ADDENDUM NUMBER ONE (1)

Issued 04/24/2025

Project: INNER PERIMETER ROAD UTILITIES EXTENSIONS

Project No. 25-05-702

GALVANIZED SAFETY
GRATE DETAIL

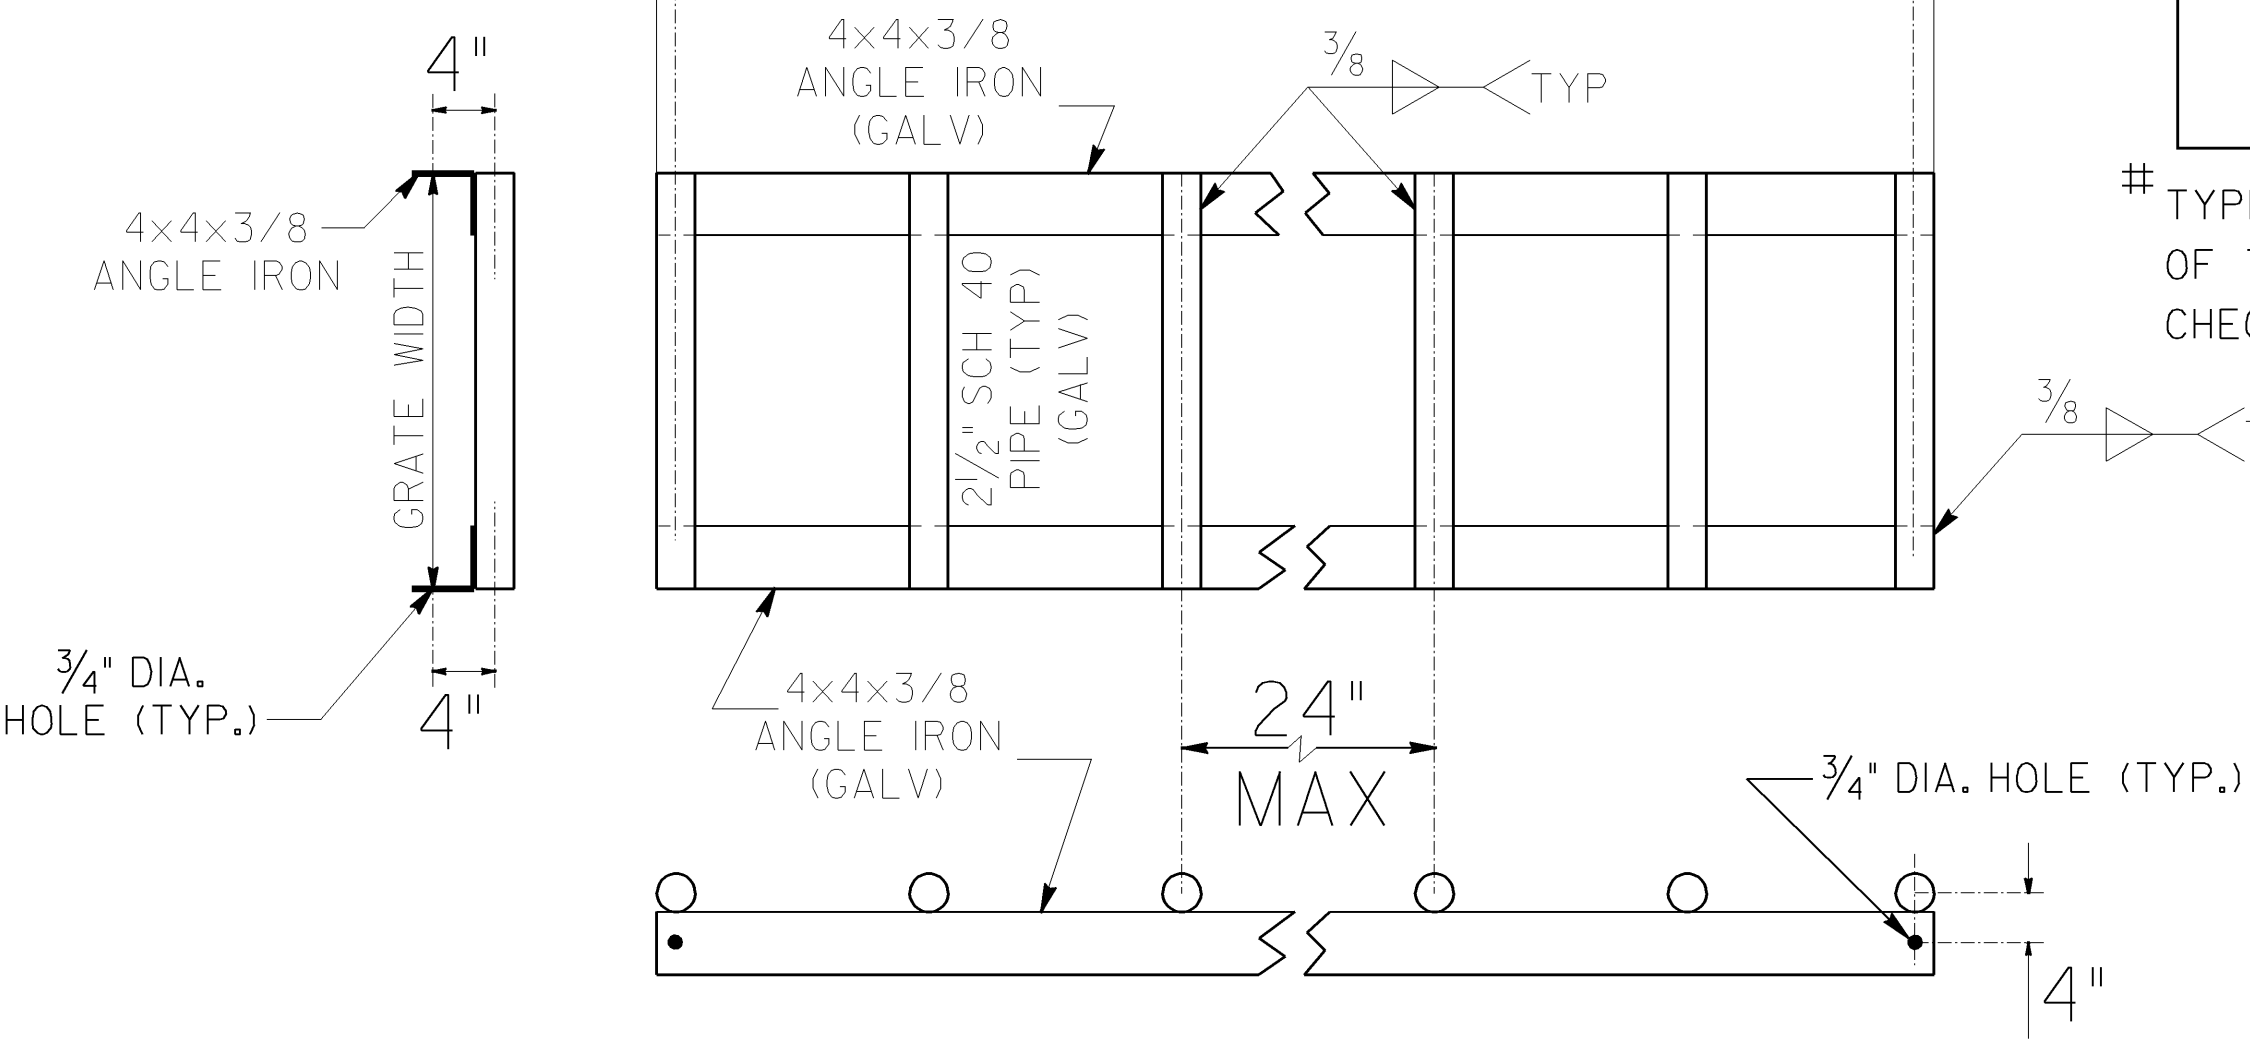
7. RCP & SES at pump station: does it have to be DOT stamped? GUY RENTZ OF THE GDOT AREA OFFICE STATES: "Safety Ends must meet GDOT Standard (1122-3). No DOT inspection stamp required. (attached standard)"
